BUILDING CODE OF AUSTRALIA COMPLIANCE ASSESSMENT REPORT FOR DA SUBMISSION

MIXED USE DEVELOPMENT COMPRISING OF 4 BUILDINGS

93-107 CECIL AVENUE AND 9-10 ROGER AVENUE, CASTLE HILL

REPORT NO. ► 13685 Rev. 01

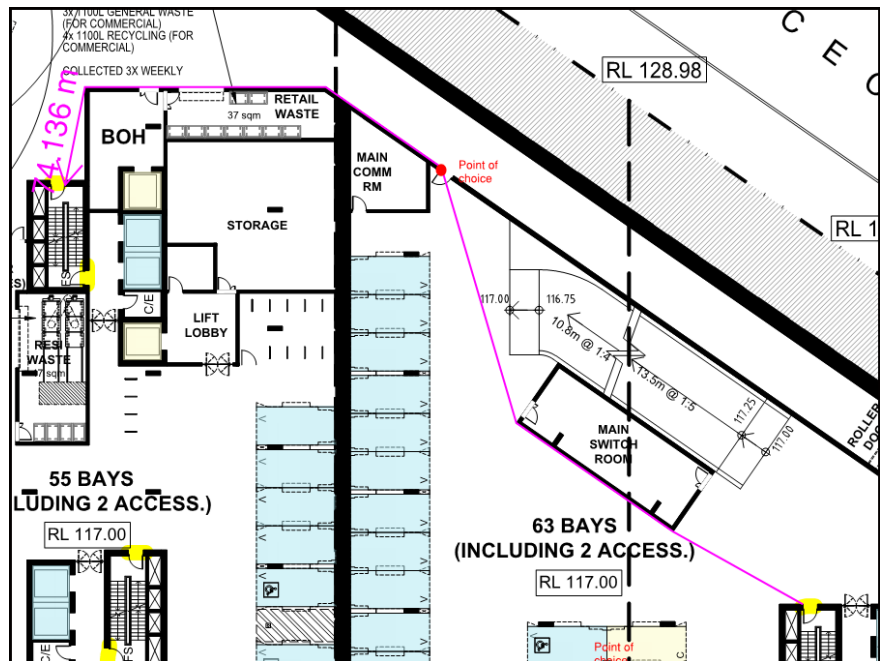
Lower Ground: The distance between the alternative exits exceeds 60m (circa 66.9m)

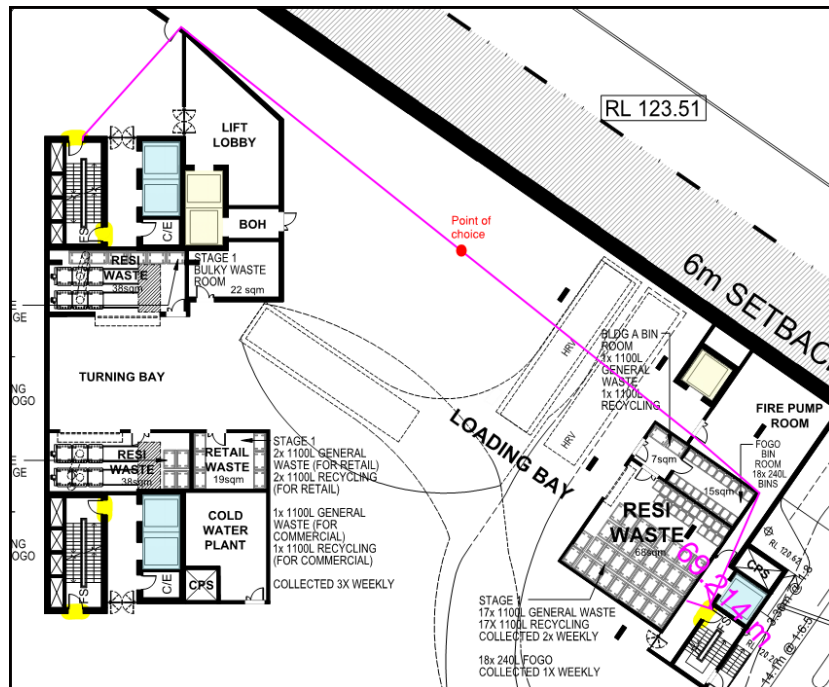
Lower Ground: The distance between the alternative exits exceeds 60m (circa 74.1m).

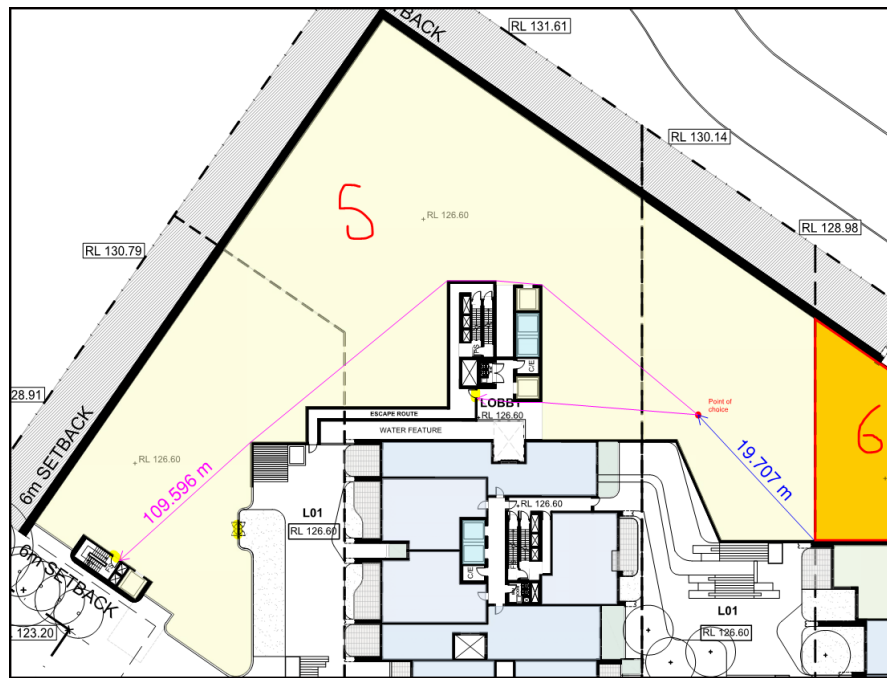
Lower Ground: The distance between the alternative exits exceeds 60m (circa 69.2m).

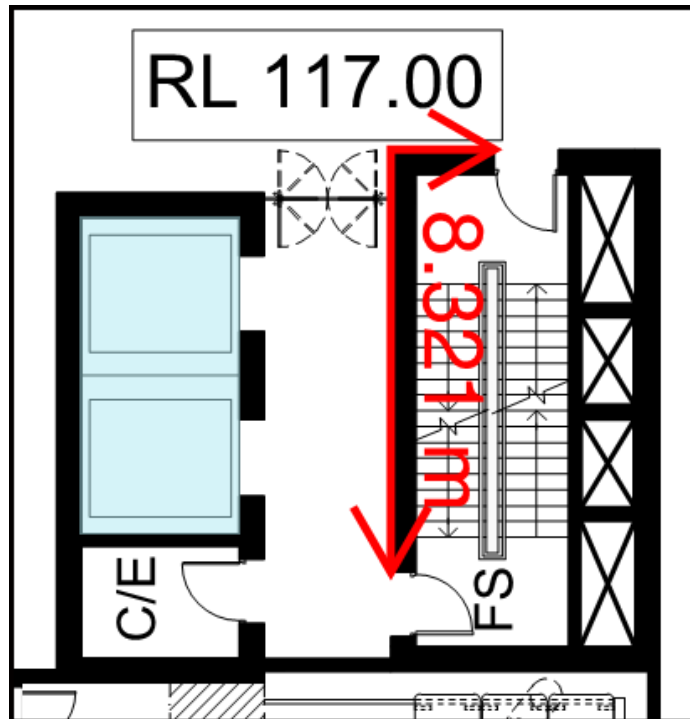
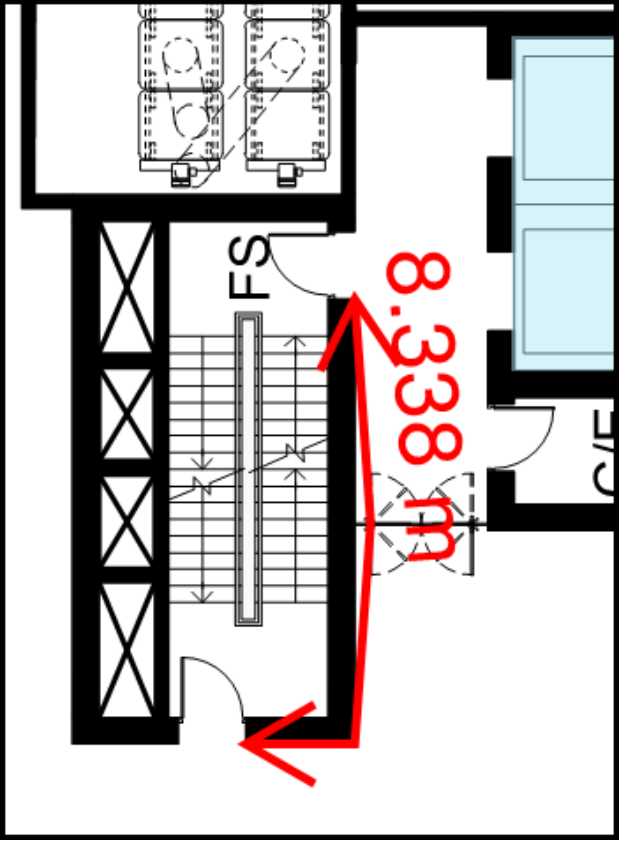
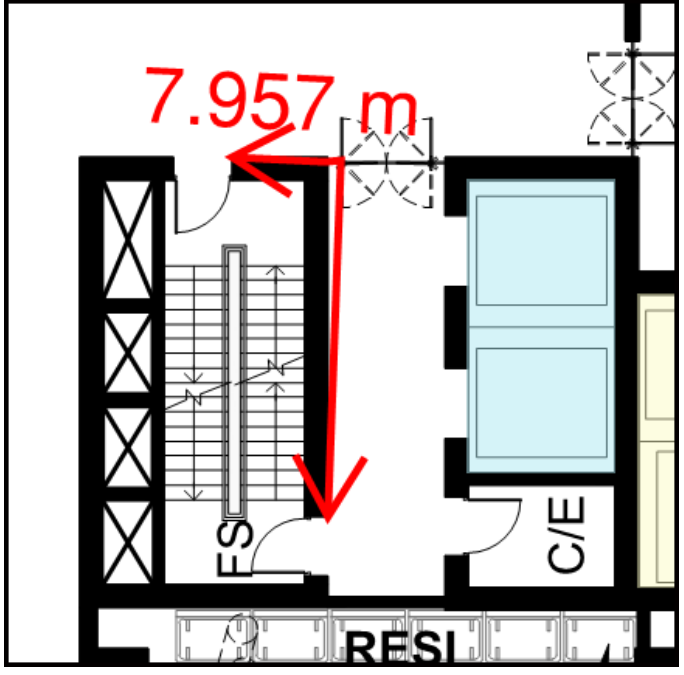
Basement 2: The distance between alternative exits is less than 9m in the following areas:
